Model: Martini-C1		Date: 13-Sep-02	No.: RB064001
Subject: ROM History (Martini-C1 LCDC/Language)		Prepared by: K. Miura	
From: Technical Services sec. Service Planning Dept.			
Classification:	<input type="checkbox"/> Troubleshooting <input type="checkbox"/> Part information <input type="checkbox"/> Action required <input type="checkbox"/> Mechanical <input type="checkbox"/> Electrical <input type="checkbox"/> Service manual revision <input type="checkbox"/> Paper path <input type="checkbox"/> Transmit/receive <input checked="" type="checkbox"/> Retrofit information <input type="checkbox"/> Other ()

Model: Martini-C1		Date: 13-Sep-02	No.: RB064002
Subject: Service Manual Revision		Prepared by: K.Miura	
From: Technical Services sec. Service Planning Dept.			
Classification:	<input type="checkbox"/> Troubleshooting <input type="checkbox"/> Part information <input type="checkbox"/> Action required <input type="checkbox"/> Mechanical <input type="checkbox"/> Electrical <input checked="" type="checkbox"/> Service manual revision <input type="checkbox"/> Paper path <input type="checkbox"/> Transmit/receive <input type="checkbox"/> Retrofit information <input type="checkbox"/> Other ()

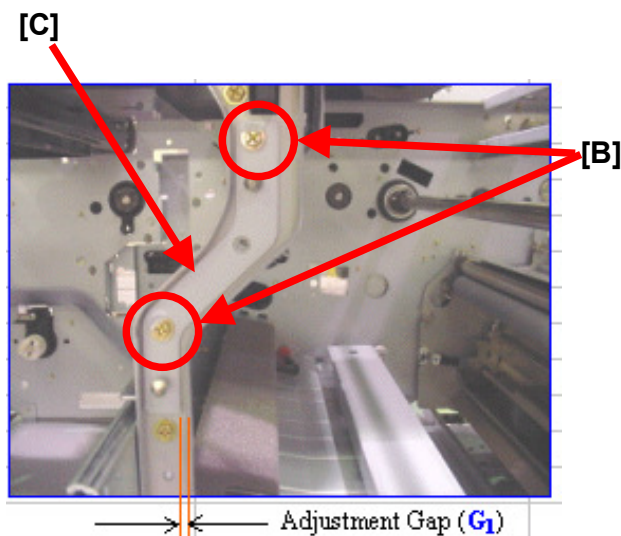
Due to a damaged special tool used on the production line, a 2.3mm gap developed between the positioning plate securing the transfer belt unit and the right edge of the machine frame (gap G₁ on next page, which should normally be about 1.5mm).

2. Remove the PCU Inner Cover (P/N B0651313), then remove the Transfer Unit Guide Plate [A].
3. Loosen the 2 paint-locked screws [B].
4. Insert a 1.5mm feeler gauge into the gap between the positioning plate [C] and the right edge of the machine frame (gap G_1 in photo below), then tighten the two positioning plate screws.

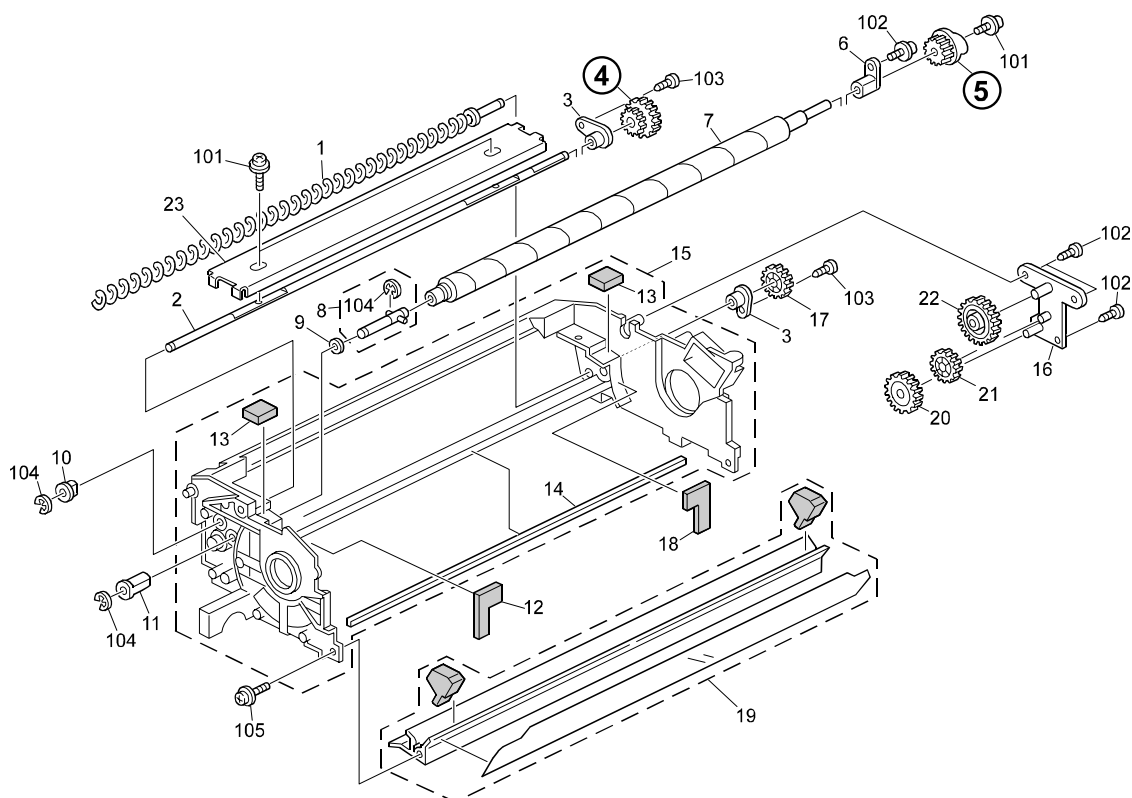
Noise from the PCU brush roller gear (PCU3 section 37, pg. 87, index #4, 5; P/N #B0652425, B0652428). In some cases the brush roller gear may break and black lines may appear, because the brush roller does not rotate.

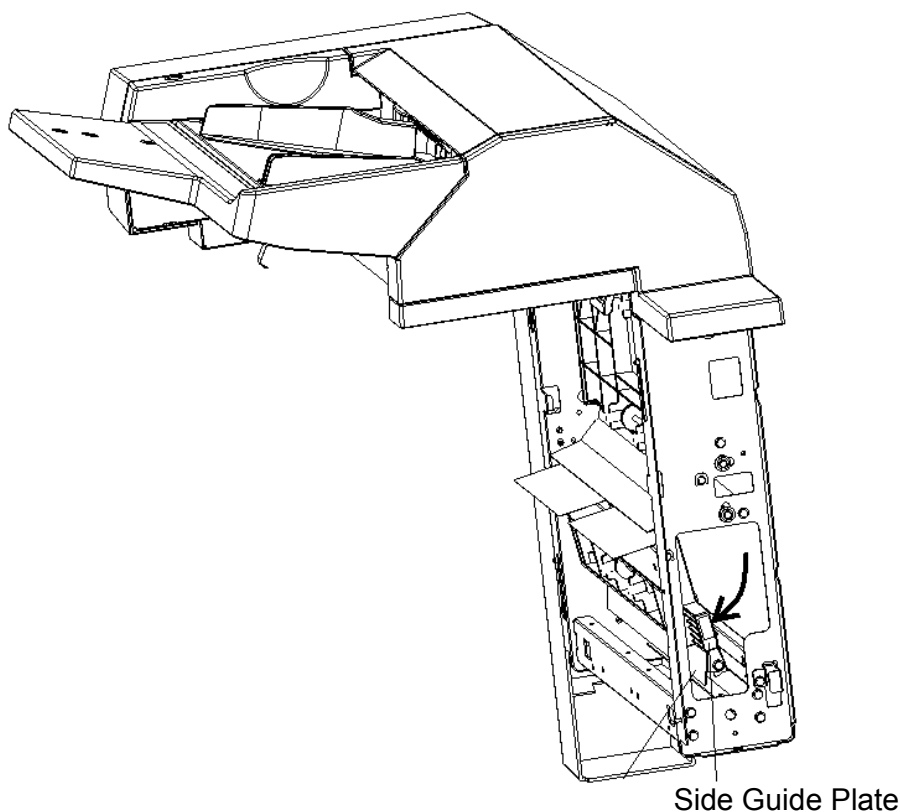
Please add the following note to **Step 19** of the installation procedure on page 1-38 of the Service Manual (illustration below for reference).

Note: When installing the finisher with the cover interposer tray, be sure to release (unlock) the entrance guide plate before docking the finisher with the machine. If the finisher is docked with the plate in the locked position, the plate may be damaged or fall off.

Removing the Steel Ball:

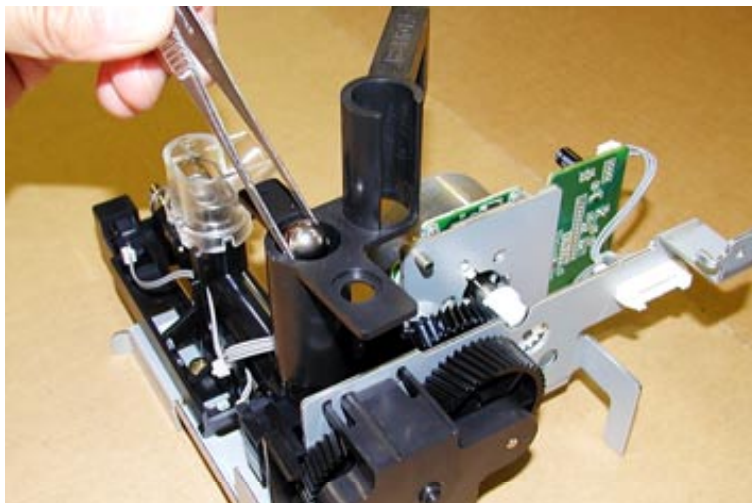
Note: The length of the coil in the Waste Toner Vertical Transport Unit has been increased as shown below (new coil on the left, old on the right). It is therefore necessary to remove the steel ball to prevent the loud noise that will occur if the coil contacts the ball.

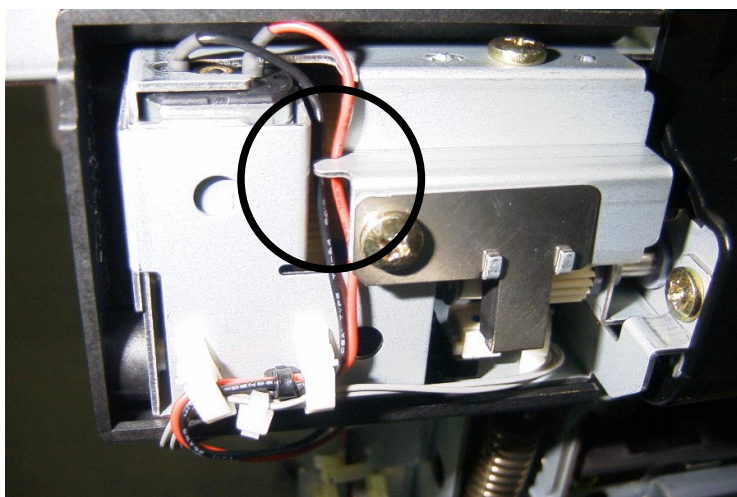
The harness position has been changed as shown below.

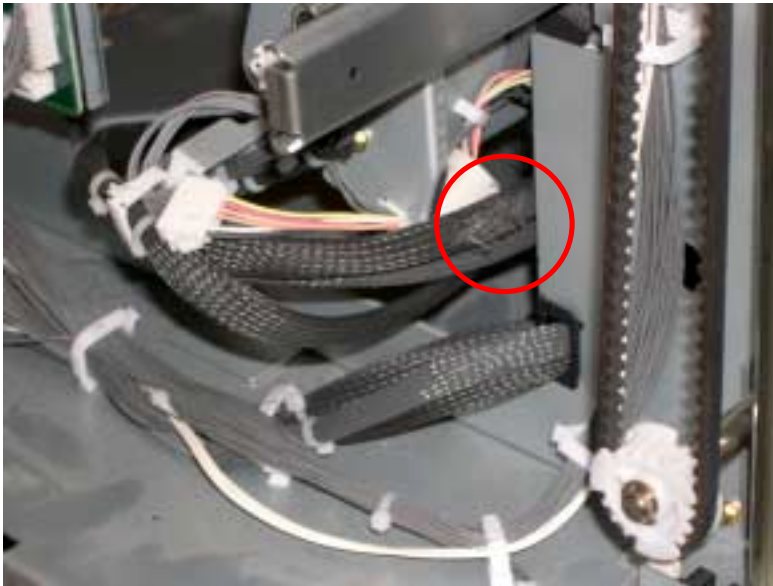
The outside of the stapler harness is damaged in the area shown in the photo. In some cases, a short circuit occurs in the damaged area.

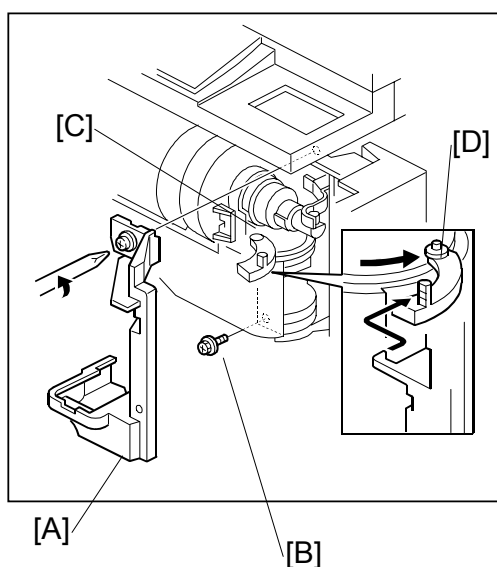
The following procedures in the Service Manual were changed (pg. 1-11).

- **Note:** Steps 5-13 of the procedure on pg. 1-11 were not changed.
- **IMPORTANT:** As mentioned below, before you begin the procedure on pg. 1-11, make sure to **remove the toner bottle first**. If the toner bottle is in the machine when you do this procedure, **the toner bottle holder can be damaged**.
